FACILITY: MONTICELLO NUCLEAR GENERATING PLANT

SUMMARY OF MEETING TO DISCUSS MONTICELLO 10 CFR §50 APPENDIX J EXEMPTION REQUEST

MONTICELLO - APPENDIX J EXEMPTIONS

Figure 1. Testable Check Valve (typical of all 4)

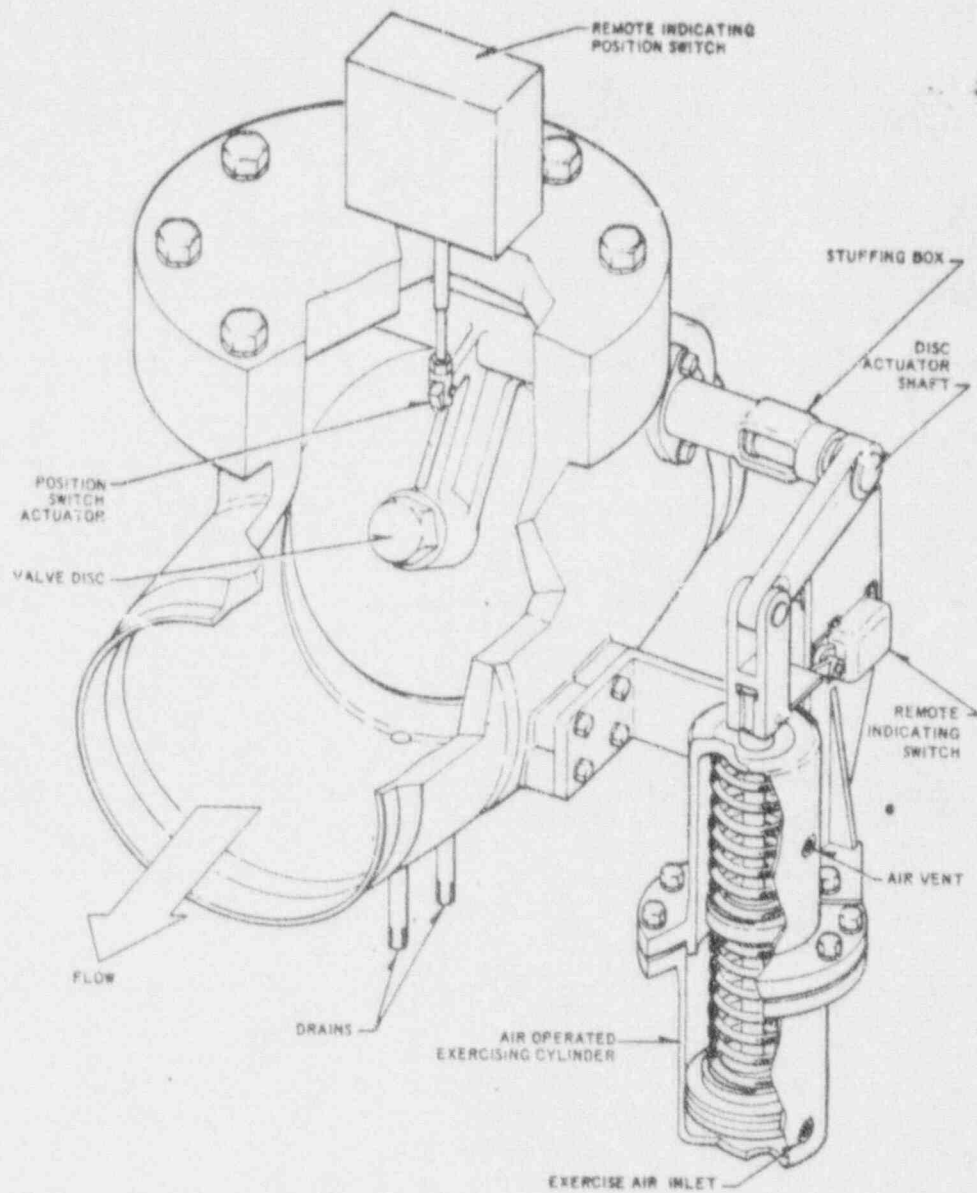
Testable check valves are installed in each core spray and low pressure coolant injection (LPCI) line (Figures 1, 2, and 3). Table 5.2.3 of the Monticello FSAR lists these valves as the inner isolation valve in each line. Each line has two motor operated valve: immediately outside the containment vessel which serve as the outside isolation valves. These motor operated valves are either normally open or open following a safeguards actuation signal. They may be closed manually by an operator in the control room.

The testable check valves in each core spray and LPCI line have been included in the Monticello Type C test program. They have consistently failed to meet the Technical Specification limit on maximum air leakage for any penetration or isolation valve of 17.2 scfh at 41 psig. The valves have been disassembled for maintenance on the following occasions to enable them to meet this criterion:

Alternative (a) is the path we have followed to date. No improvement in the performance of these valves as containment isolation valves has resulted. In our judgement, they cannot be made to satisfy containment leakage acceptance criteria.

1. Request to exempt testable check valves in the LPCI and Core Spray Lines from Type C testing - NSP requested that a second motor operated valve outside containment be designated the redundant isolation valve. NSP will consider a Technical Specification change which would establish a maximum allowable liquid leakage from the piping and components outside the outboard isolation valves. The liquid leakage limit would be used to demonstrate that there is a sufficient period of time, prior to system depressurization, to manually close either motor operated valve such that the check valves will not become containment leakage barriers at any time.

Figure 2. Core Spray System Containment Penetrations

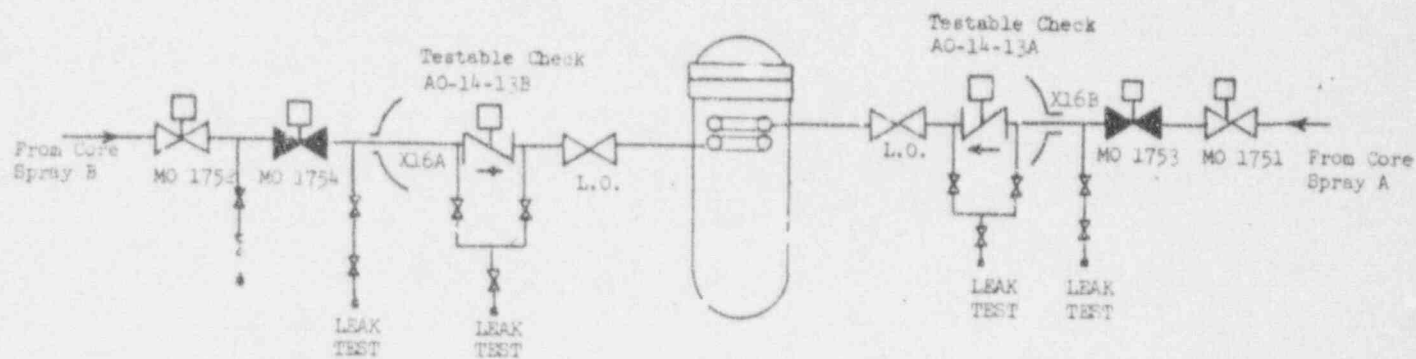
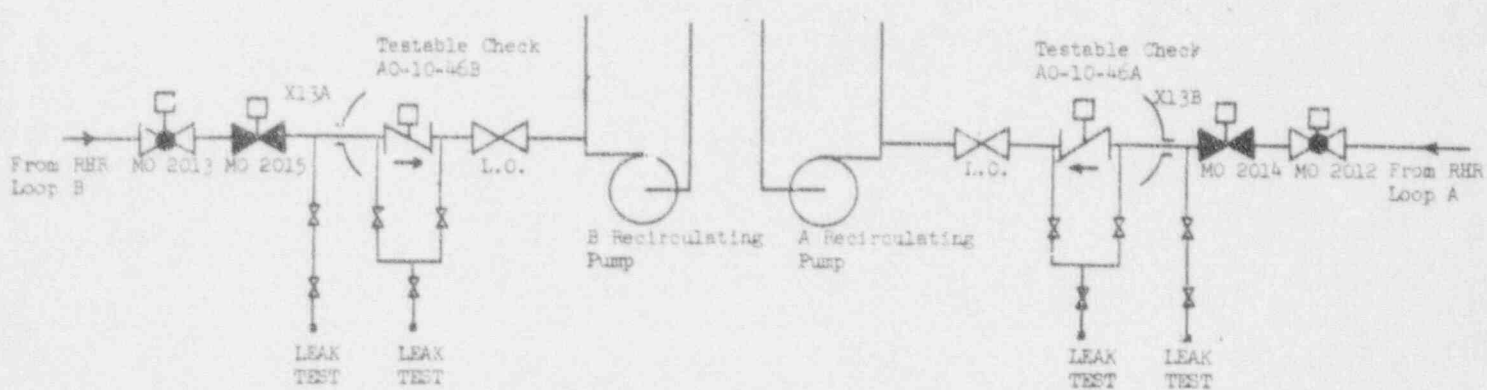
Alternative (c) was proposed by NEP in a letter dated May 5, 1976 from Mr. L. G. Mayer, to Mr. Victor Stello, USNRC, "Request for Exemption from Certain Requirements of 10CFR50, Appendix J." This exemption request proposed a redefinition of which valves in the lines in question should be considered the containment isolation valves.

Alternative (c) is a valid solution for the following reasons:

- a. It is not uncommon to locate both isolation valves outside containment in BWR design. In this case, the motor operated valves and lines outside containment are not subject to pipe whip or missile damage. The valves, and all parts of their associated systems, are designed to withstand the design basis earthquake. Locating one valve inside containment in each of these lines offers no advantage.

- b. Automatic closure of isolation valves in these lines is not required. The post-accident function of the valves is to open and remain open. A core spray or LPCI line becomes a significant leakage path only if 1) a pump fails to start - 2 pumps in the case of a LPCI circuit, and 2) the associated line breaks outside containment, and 3) the testable check valve inside containment fails to seal.

Figure 5. Drywell Spray Containment Penetrations

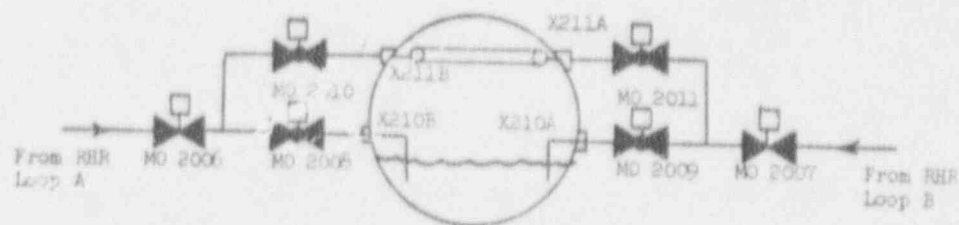
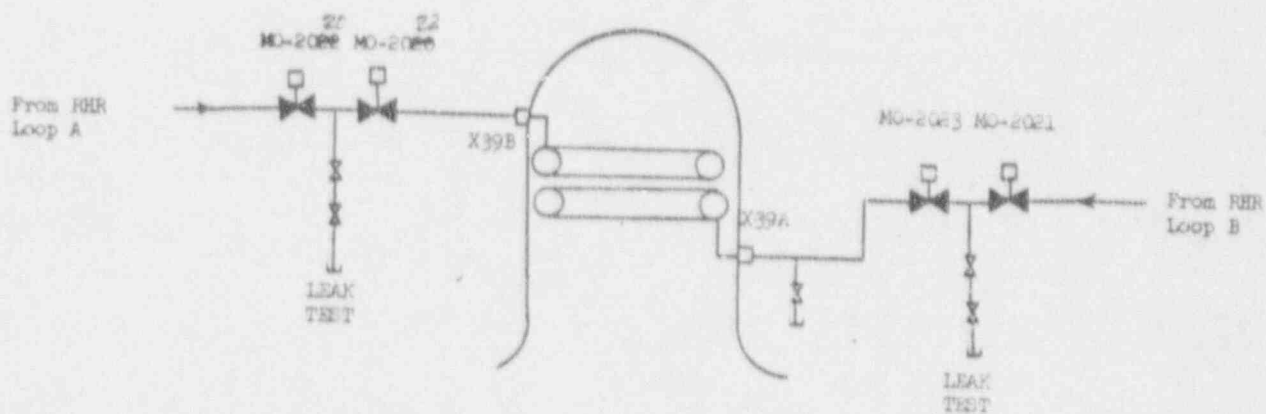
Two motor operated valves are installed in each torus spray and drywell spray line (Figures 4 and 5). These valves are normally closed, but may be opened following an accident to suppress torus or drywell pressure. Exemptions are requested because these penetrations will not constitute a containment leakage path and because of the following testing difficulties:

Torus Spray Line Isolation Valves	No provision for testing
Drywell Spray Line Isolation Valves	Inner isolation valve cannot be tested in the correct direction. This valve is a wedge type gate valve.

Following an accident these lines are pressurized by the RHR pumps to a pressure well above P_a . Each RHR circuit is supplied by two pumps. No potential for containment leakage exists under normal conditions.

If both RHR pumps in a circuit fail to start, some leakage past the motor operated valves in each line can be expected to occur. This leakage will be retained within the RHR piping, however, and presents no problem since the RHR piping is a low leakage barrier which is effectively an extension of the containment boundary.

During the long-term period following an accident, one RHR circuit may require maintenance. The RHR circuit is isolated from the torus and the drywell by the two motor operated valves in each line. At this time, containment pressure is well below P_a and leakage will be minimal. In the event both motor operated valves in a torus or drywell spray line leak excessively, additional maintenance block valves are provided in each RHR circuit to assist in sealing off any containment leakage. All lines will be water filled, a condition which further reduces the magnitude of any leakage.

Modifications to test these penetrations in accordance with Appendix J include the addition of a stop valve between each inboard isolation valve and the containment vessel and a test connection in each line. The cost involved in making these modifications is estimated to be \$50,000 - \$100,000. This expenditure would not lead to any significant improvement in containment system performance.

2. Request to exempt torus and drywell spray motor operated valves from Type C testing - NSP will determine if the RHR system pressure can be maintained following a postulated loss-of-coolant accident, considering potential single active failures and post-accident, maintenance functions. If a system pressure, greater than containment pressure, can be maintained under such circumstances

then the valves in question would not serve as containment leakage barriers.
